P 515300-A

ON-SITE SEWAGE DISPOSAL SYSTEM HOWARD COUNTY HEALTH DEPARTMENT BUREAU OF ENVIRONMENTAL HEALTH

SUBDIVISION: Wellington West II LOT NUMBER: 3

ADDRESS: 15233 Bucks Run Drive PROPERTY OWNER: Pulte Homes

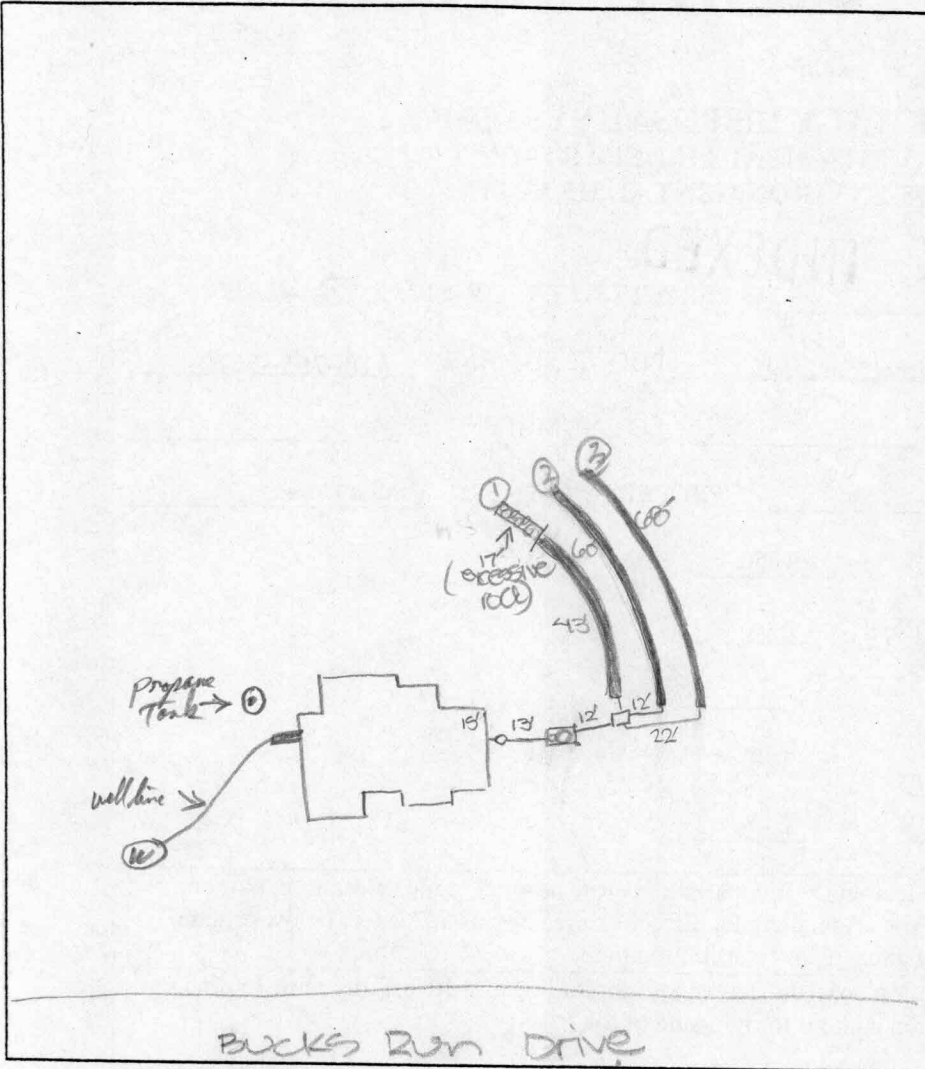
INSPECTION COMMENTS: 6/26/01 first trench stopped @ 43' in length - excessive rock beyond. second and third trench specs were revised based on soil types to conserve remainder of SDA. DCC 6/26/01 P.M. OK to continue work. DCC 6/27/01 A.M. OK to cover work - need 6" c.o. and manhole. DCC 8-10-01 WPI OK - COVER KG/RP

6/27/01 P.M. FINAL INSP - OK to cover all septic work. DCC
